Planning & Development Division
Planning & Economic Development Department

File Number	PL 22-088	Contact	Kyle Deming, kdeming@duluthmn.gov	
Type	Variance – building height	Planning Commission Date		June 14, 2022
Deadline for Action	Application Date	May 17, 2022	60 Days	July 16, 2022
	Date Extension Letter Mailed	May 23, 2022	120 Days	September 14, 2022
Location of Subject		3731, 3819, 3829, 3867 London Rd.		
Applicant	Stocke Construction	Contact	Ted Stocke	
Agent		Contact		
Legal Description		Lots 13, 14, 23-26, Block 1, London East Division (010-3075-00130, -00140, -00230, -00240, -00250, -00260) and Lots 8 & 9, Block 31, Rearrangement of East Duluth and First Addition to East Duluth (010-1370-05060)		
Site Visit Date	June 1, 2022	Sign Notice Date		June 1, 2022
Neighbor Letter Date	May 26, 2022	Number of Letters Sent		19

A variance to allow a one-family dwelling to be constructed at each address listed above that is 40 feet tall instead of the 30 feet maximum building height per UDC Section 50-14.5. The project is within the London East twinhomes development.

PL22-088
Building Height Variance
3731, 3819, 3829, &
3867 London Rd.
Stocke Construction

Proposed building concept at 40 feet tall

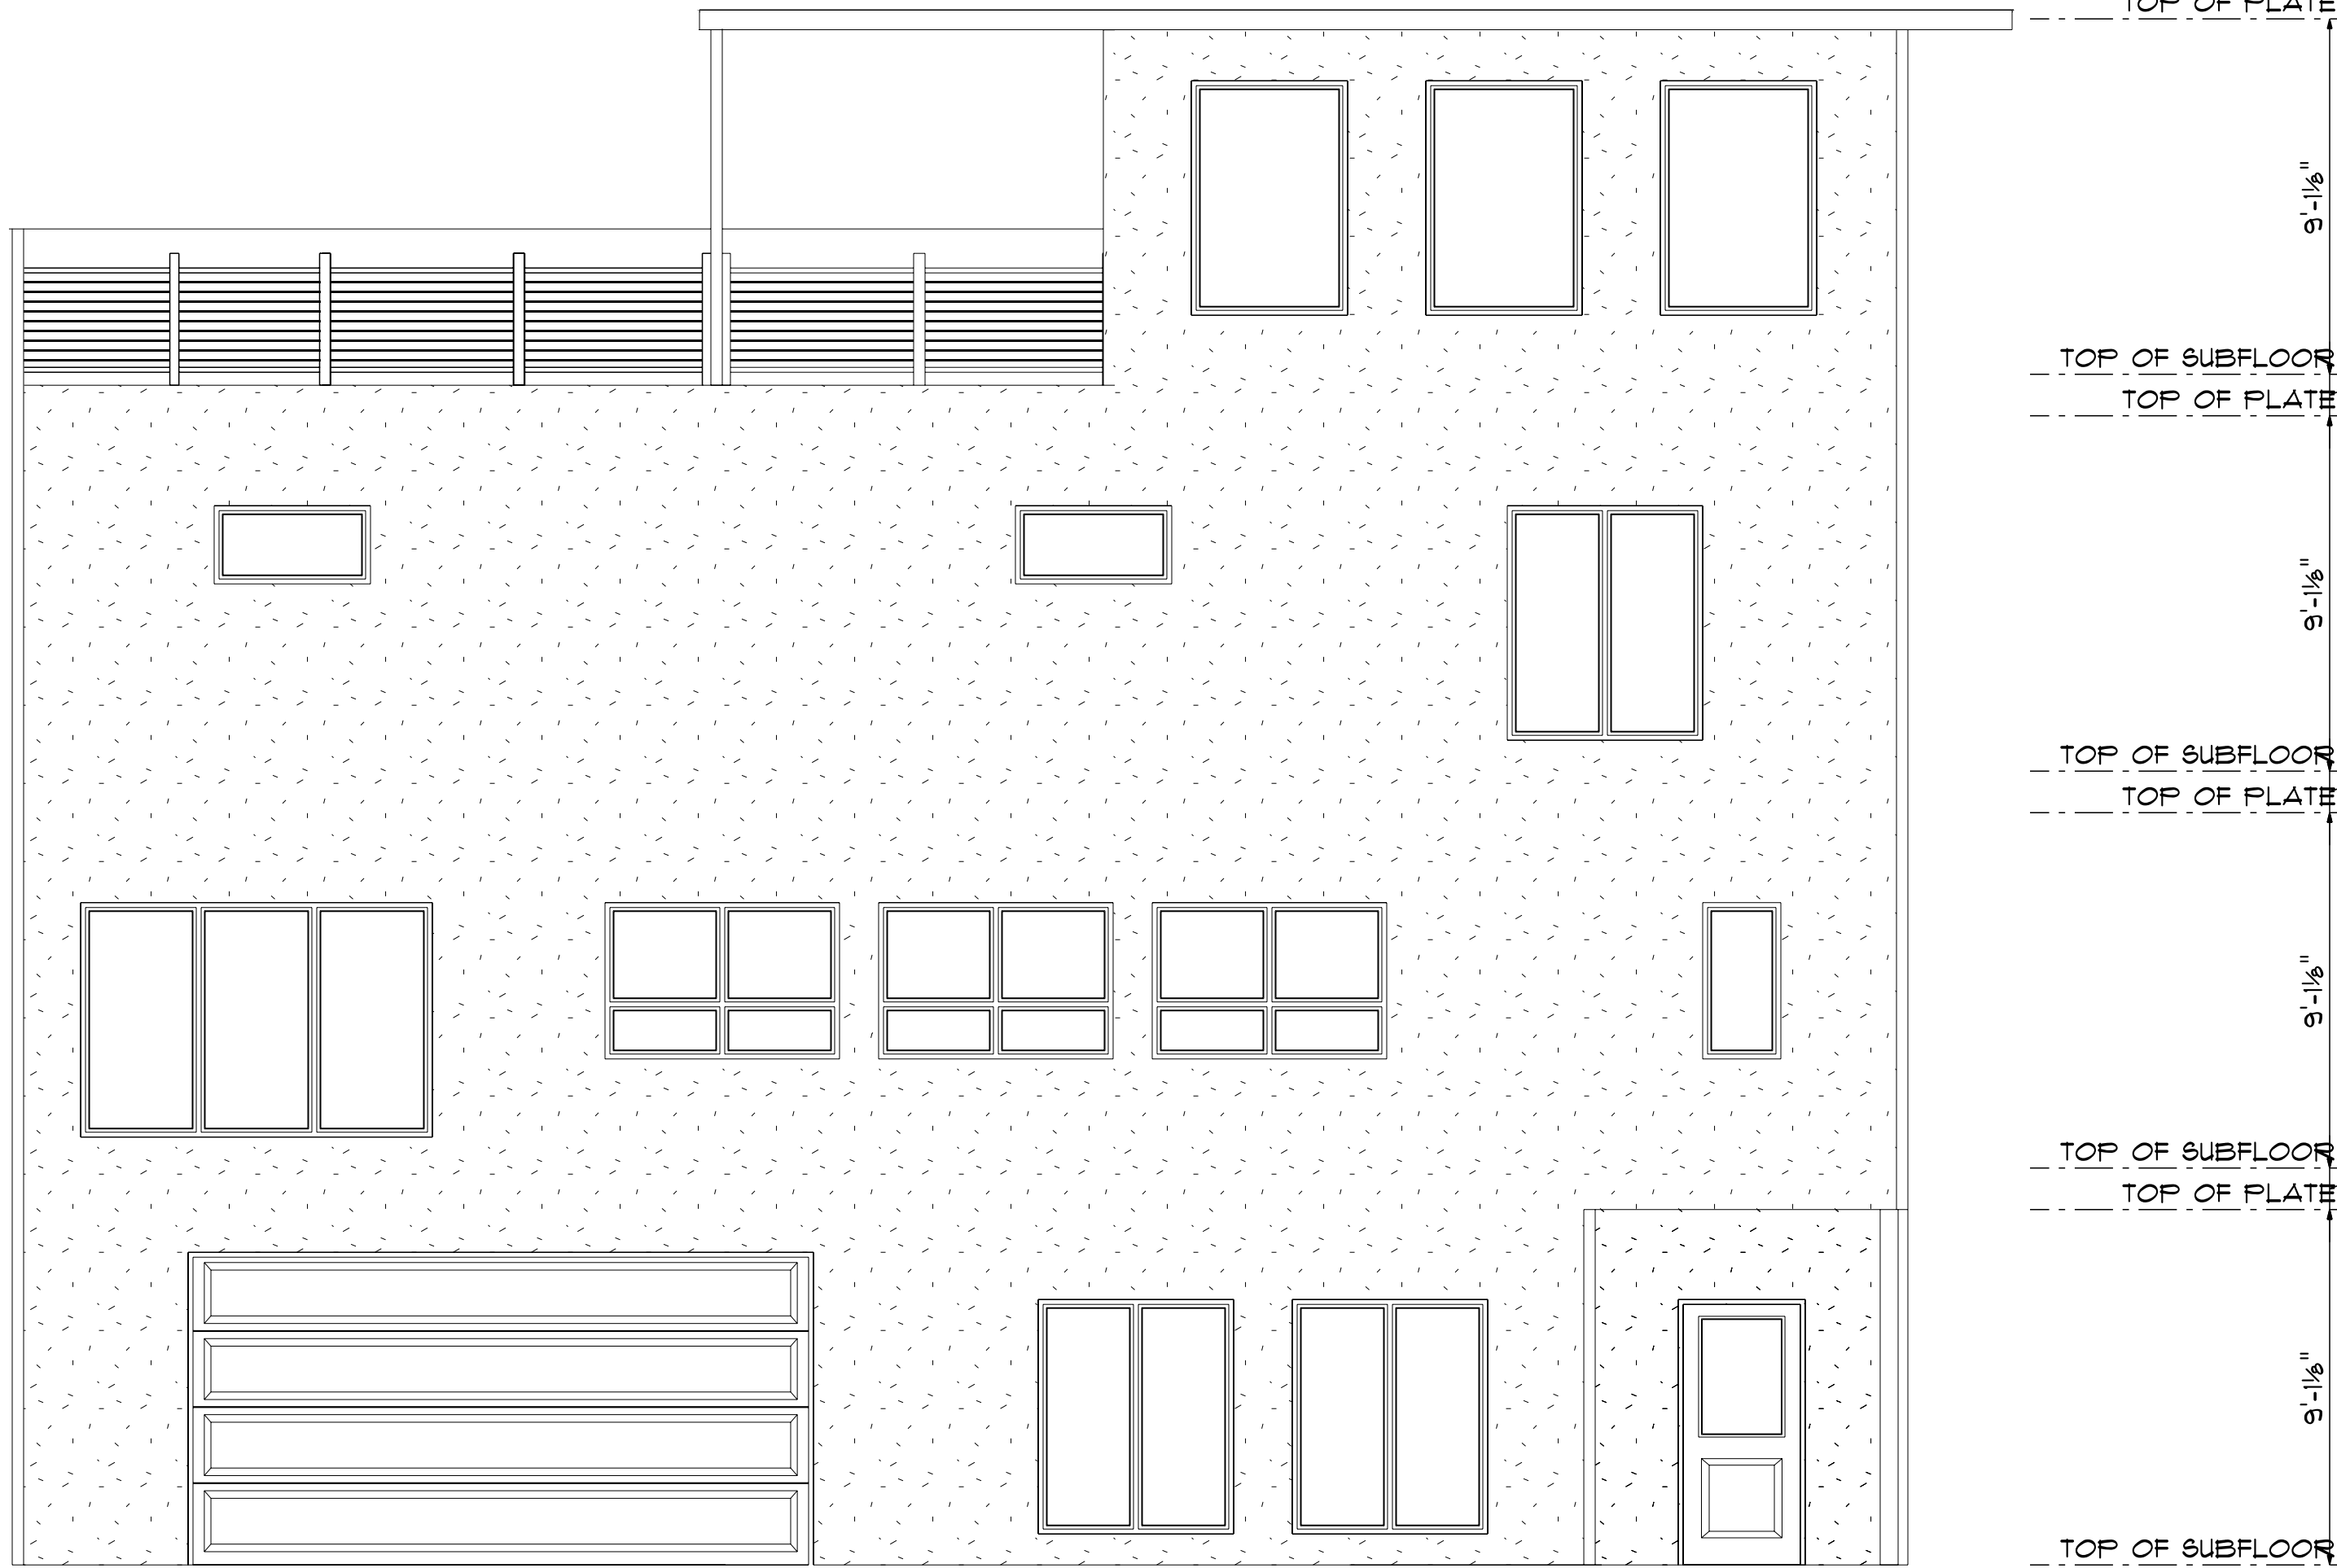
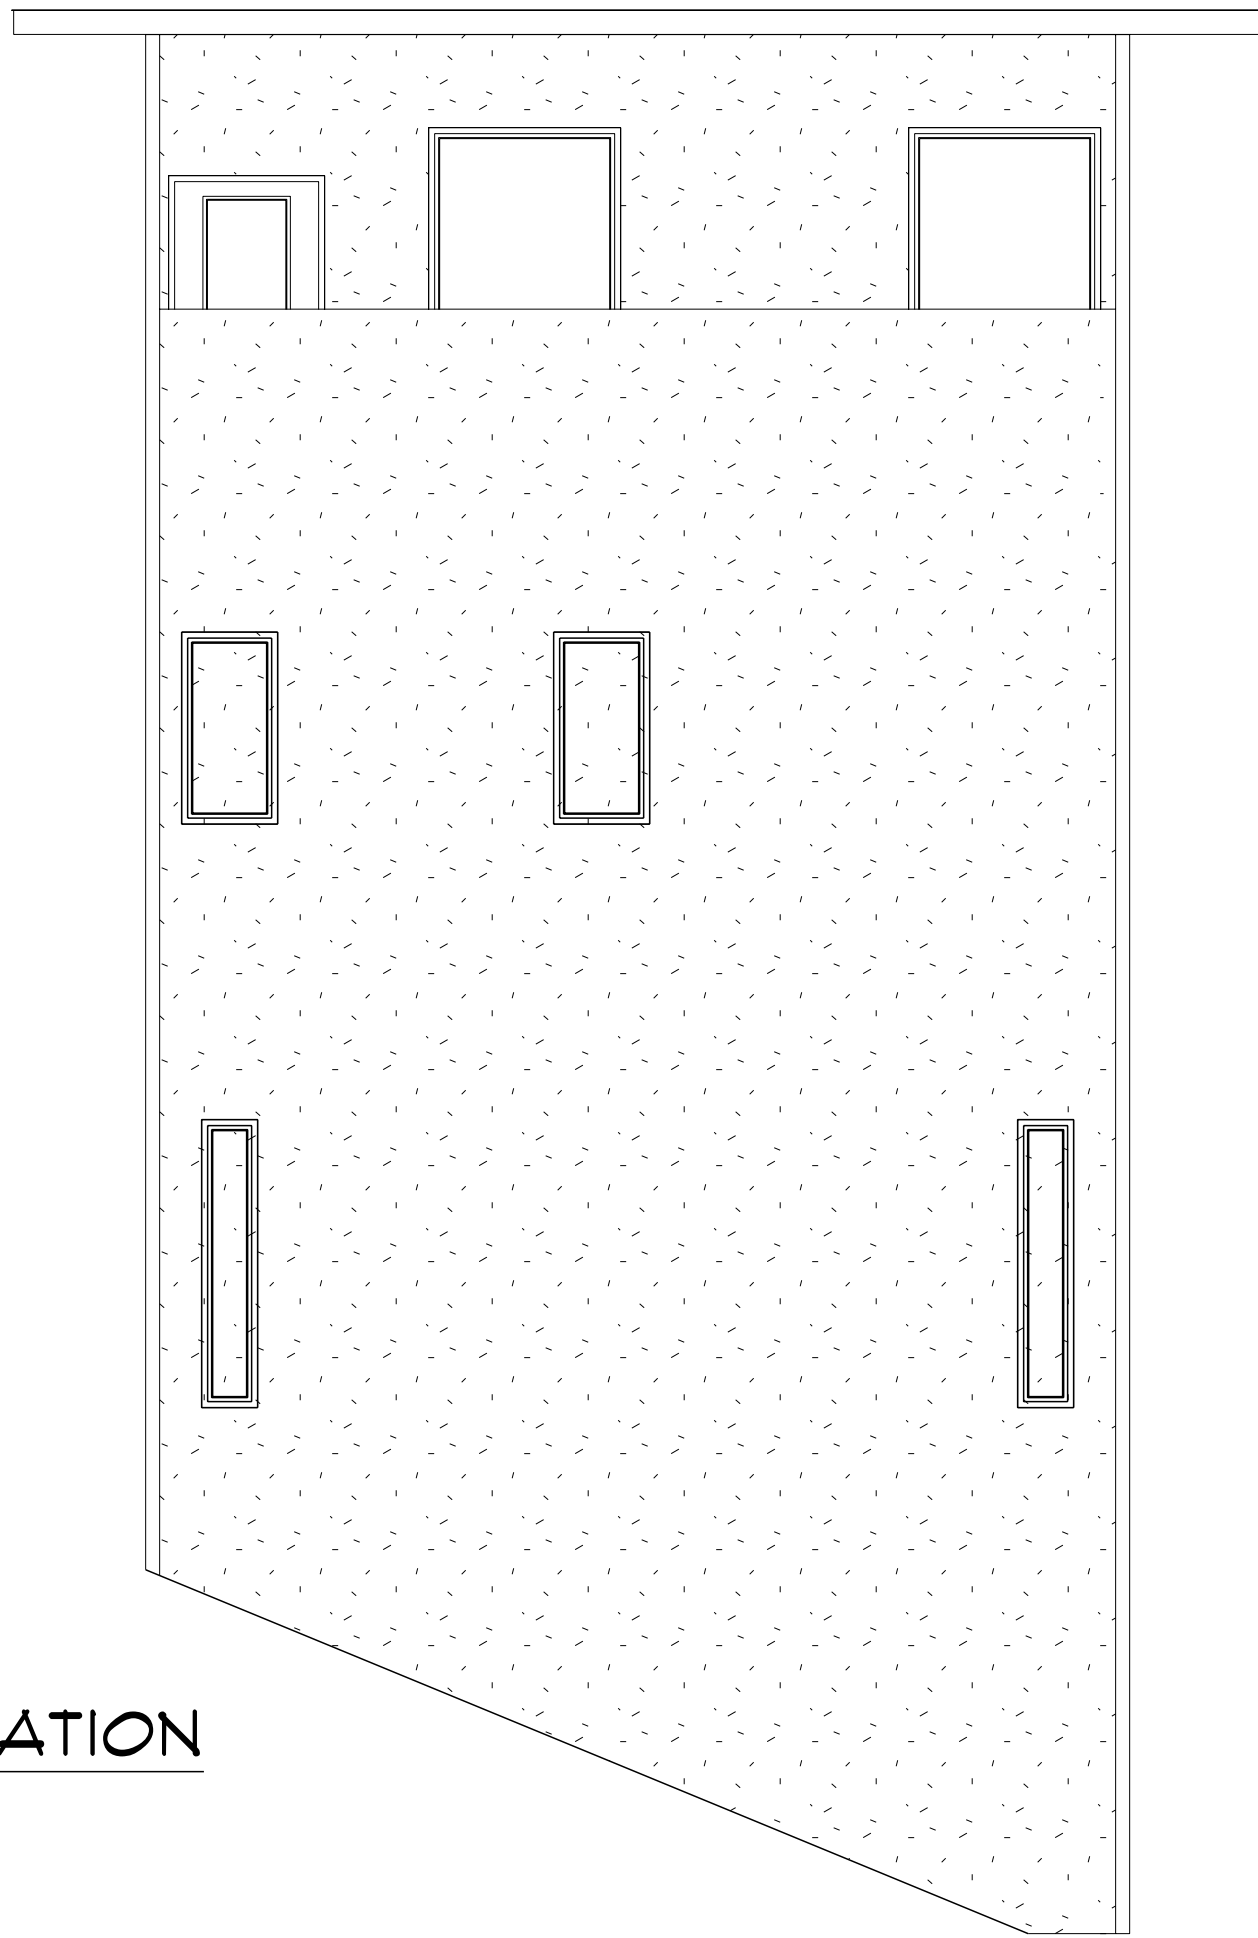
1. The site is part of the 3.14 ac. London East twinhome development.
2. Applicant is proposing to construct 4 one-family dwellings in the eastern part of the development that would be 40 feet tall instead of the 30 feet allowed in the R-1 district. According to the plans, the portion of the building exceeding the maximum height consists of a 20-foot-wide by 22-foot-deep enclosed space, a 10-foot-wide by 22-foot-deep arbor, and an 18-foot-wide by 22-foot-deep open patio with standard height fall protection walls or railings

7. Granting the variance will not alter the essential character of the area because the proposed 48-foot-wide, 40-foot-tall structures will have a similar bulk to the twin homes on the adjacent lots within the development. Additionally, across London Rd. are three large apartment buildings, one 170 feet long by 3 stories, one 270 feet long by 3 stories, and one 240 feet long by 6 stories tall. The recently completed Zvago condominium building is 4 stories tall and the Ecumen Lakeshore complex includes 3-story buildings of a similar height when including the steeply pitched roofs.

11. Granting the variance is not expected to unreasonably diminish established property values in the area because the building height will not impact the view from the northwest compared to the pre-development site condition that consisted of dense tree cover in excess of the proposed building heights. The building locations far back from London Road are not expected to impact the values of property on the lower side of London Road due to the distance and mature vegetation on the properties providing screening.

- 1) The project be limited to, constructed, and maintained based on the plans submitted with the application that shows the portion of the building exceeding the maximum height consisting of a 20-foot-wide by 22-foot-deep enclosed space, a 10-foot-wide by 22-foot-deep arbor, and an 18-foot-wide by 22-foot-deep open patio with standard height fall protection walls or railings.
- 2) Any alterations to the approved plans that do not alter major elements of the plan may be approved by the Land Use Supervisor without further Planning Commission; however, no such administration approval shall constitute a variance from the provisions of Chapter 50.
